SECTION 96 SUBMISSION

DEE WHY RSL CLUB - 932 PITTWATER ROAD  
STAGE 5 CLUB EXTENSION

5B-S96-ROOF PLAN-SOUTH EAST  
Scale: 1 : 200

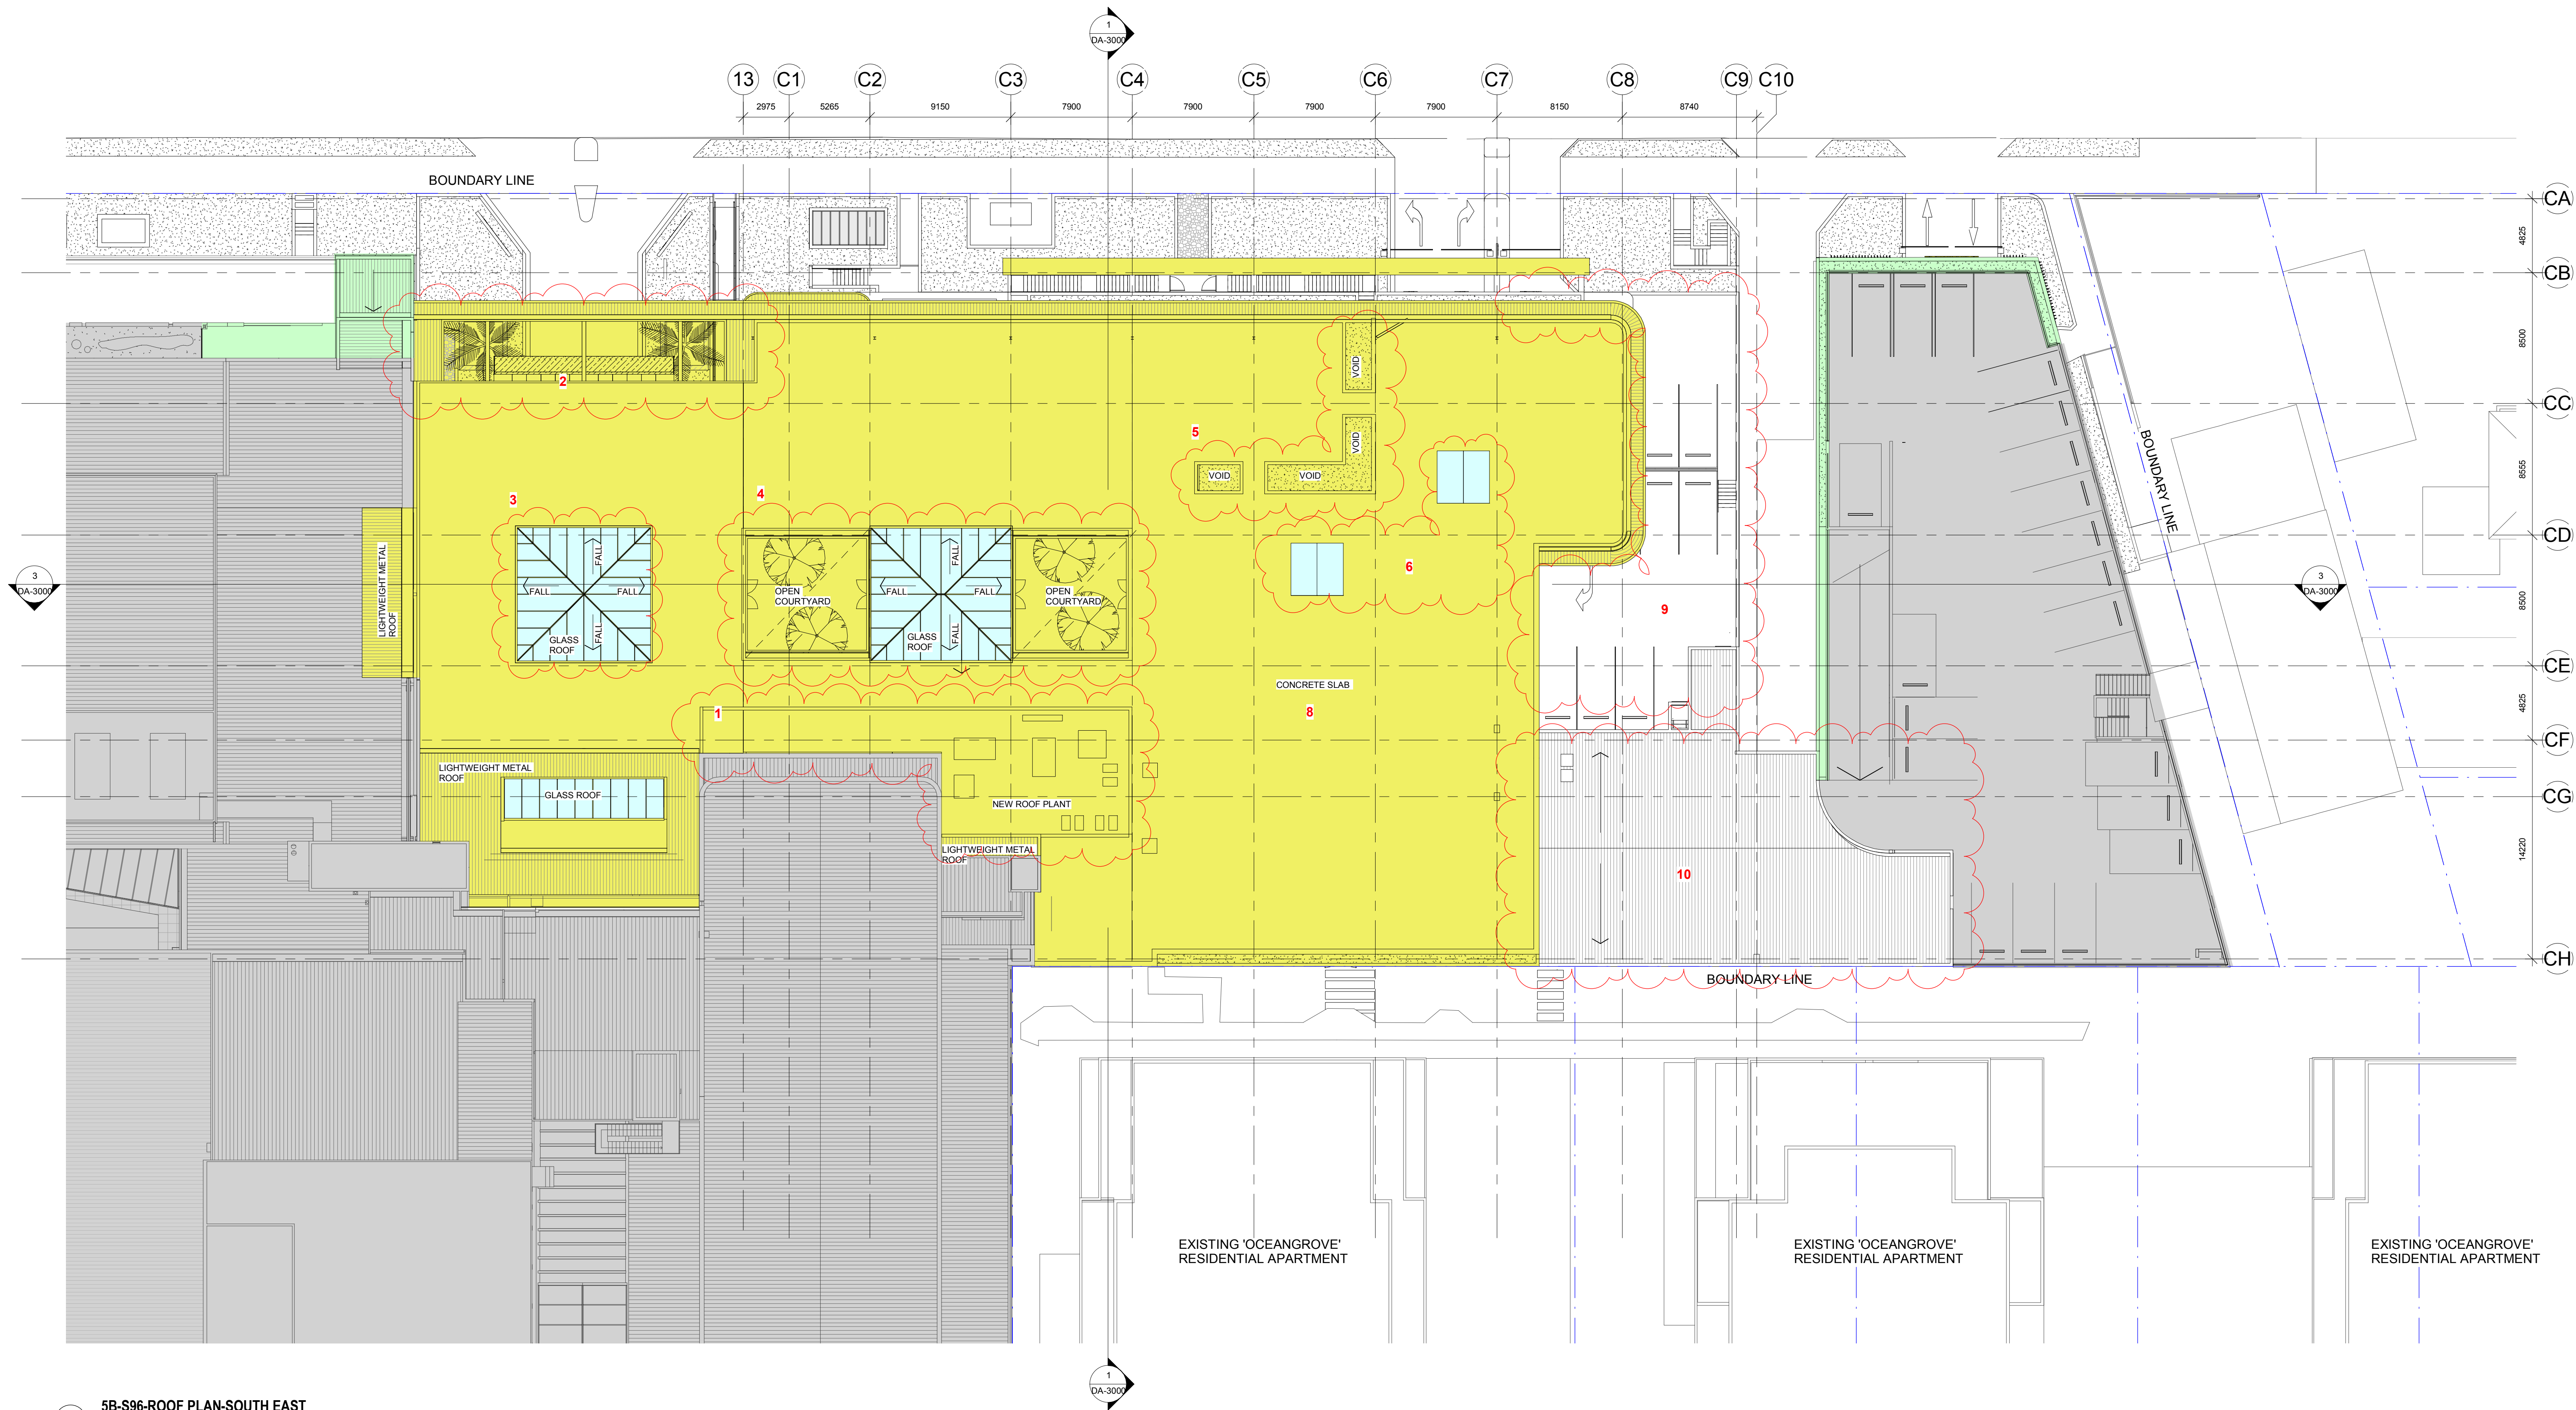
1. RELOCATED OPEN PLANTROOM AT THE ROOF LEVEL
2. MODIFIED ROOF OPENING ABOVE MAIN ENTRANCE
3. MODIFIED CENTRAL SKYLIGHT (REDUCED HEIGHT, MODIFIED PITCH)
4. MODIFIED COURTYARD: TWO OPEN COURTYARDS AND ONE SKYLIGHT COVERED AREA INSTEAD OF ONE LARGE GLASS ROOF, REDUCED HEIGHT AND PITCH

5. MODIFIED SMOKING TERRACE: ROOF OPENING, SIZE AND PLANTED AREA, AREA REDUCED BY 21m<sup>2</sup>
6. REDUCED NUMBER OF ROOF SKYLIGHTS ABOVE ASIAN RESTAURANT: 2 INSTEAD OF 6 TO SUIT THE NEW INTERNAL LAYOUT

7. MODIFIED EXIT STAIR: POSITION, CONFIGURATION, METAL ROOF NO LONGER REQUIRED
8. CONCRETE ROOF INSTEAD OF METAL DECK ROOF FOR THE MAJORITY OF THE BUILDING EXTENSION

9. NO SLAB ABOVE THE EXPOSED CAR PARK LEVEL 2 IN THE SOUTH AREA
10. NEW ACOUSTIC METAL ROOF ABOVE REVISED LOADING DOCK
11. MODIFIED FACADE APPEARANCE DUE TO CHANGES IN THE CAR PARK LEVELS, LOADING DOCK AND EGRESS STAIRS

12. REMOVED LOUVRES ON THE BACK FACADE (WESTERN FACADE) DUE TO MECHANICAL RISER NO LONGER REQUIRED / REVISED LOCATION FOR EGRESS DOORS
13. 2m WIDE INTERNAL EGRESS STAIR MODIFIED INTO TWO 1m WIDE EXTERNAL STAIRS WITH DECORATIVE BALUSTRADES

14. EXTENT OF LEVEL 2 (MAIN TRADING LEVEL) REDUCED BY 8326mm FROM THE SOUTHERN BOUNDARY AND INCREASED BY 1100mm TO THE EASTERN BOUNDARY
15. MODIFIED FACADE CURTAIN WALL MULLION BLADES

31. SOLID MASONRY WALL ADDED BETWEEN EXISTING ZONE D CAR PARK AND LOADING DOCK ACCESS.
